Town of Parker Community Development Department
 Development Review Division
 Attention: **Stacey Nerger**

Application Type: **Minor Development Plat**
 Status: **First Referral**
 Application Name: **Lincoln Professional Park Filing No. 1 MDP**
 Case/AP#: **SUB20-002**
 Referral Received: September 22, 2021
 Comments Due: October 20, 2021

Review date: **October 14, 2021**
 Plan reviewer: **Randall L. Capra, rcapra@parkeronline.org**
 Phone: 303.805.3163

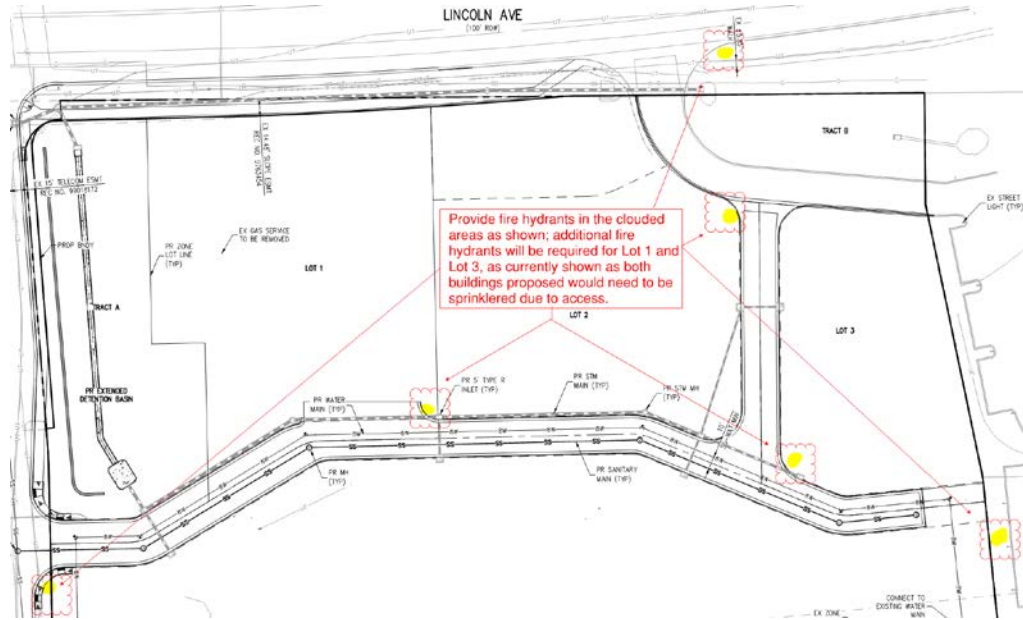
8. **Sheet 3 Overall Utility:** The overall utility drawings are incomplete; the plan set does not address fire hydrant locations for the spine roads proposed. The applicant shall address this issue and fire hydrants will be required in the following locations while noting that additional hydrants will be required on the internal lots depending upon access and use (the gas station will be required to be sprinklered as will Lot 3... as currently shown): *Partially satisfied; the applicant has noted/acknowledged/address with second submittal and has provided all fire hydrants. See location of hydrant beneath yellow highlighted notation below: Not Satisfied; the applicant has indicated that the site to the west is private property. The comment is not relevant as Planning has indicated that the access is required to punch through to the east and (whether private or public, the fire hydrant and access is required. Provide the access and the hydrant when resubmitting. Satisfied; applicant has addressed with the fourth submitta.*

- The entry off of Dransfeldt Road on to Road A
- The entry off of Lincoln Ave and the current Private Drive
- Road A (required extension) into Lot 1 Filing No.2 Peaslee Subdivision at Road A and Lot 1

- At the corner of Road B and the Private Drive
- At the corner of Road A and Road B
- At the entry of the gas station off or Road A

See below for locations required:

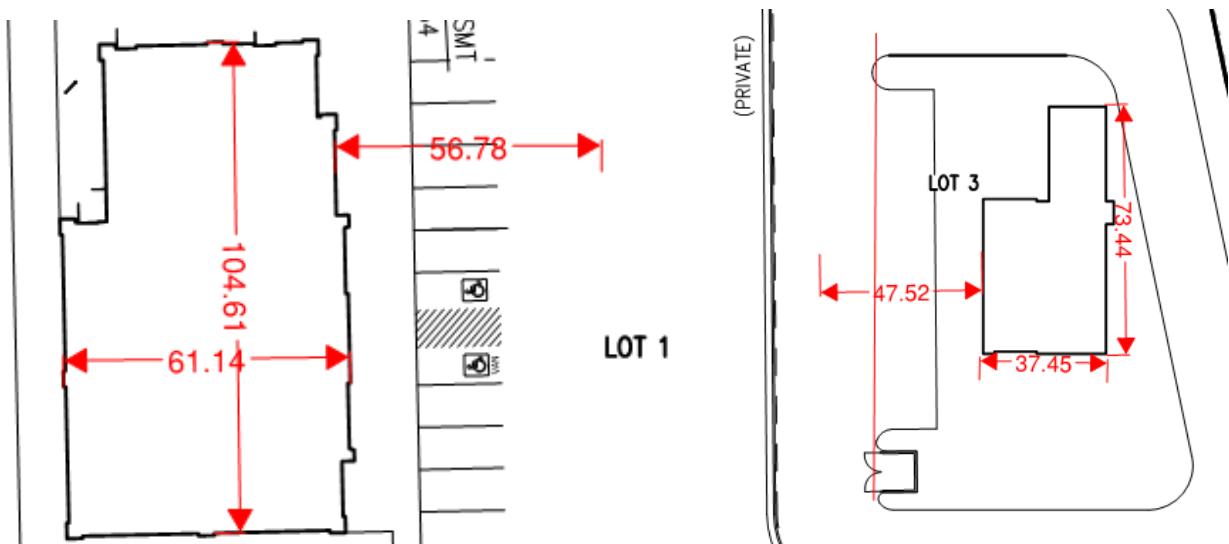
- The applicant shall be aware that additional fire hydrants (on each individual lot) will be required based upon access, occupancy type, etc. (and certainly based upon what was shown on the submittal documents). This requirement (complying with NFPA 24, section 7.2.3) will be evaluated for each individual lot as applications are submitted though it would be advisable for the applicant to plan accordingly so that cuts into new infrastructure can be avoided.

As noted above, the buildings on Lot 1 and Lot 3 (in the configuration shown) will be required to be sprinklered due to the inability to provide access to all portions of the building (as measured by an approved route by the "fire code official". Per [18 IFC 503.1.1 Buildings and Facilities], the code does allow the distance to be increased when the building is fully sprinklered. This issue shall be addressed when resubmitting. *NOTE - The location of the riser rooms must be approved; the required fire hydrants for each of the condominium buildings. Satisfied; the applicant has noted/acknowledged/address with second submittal.*
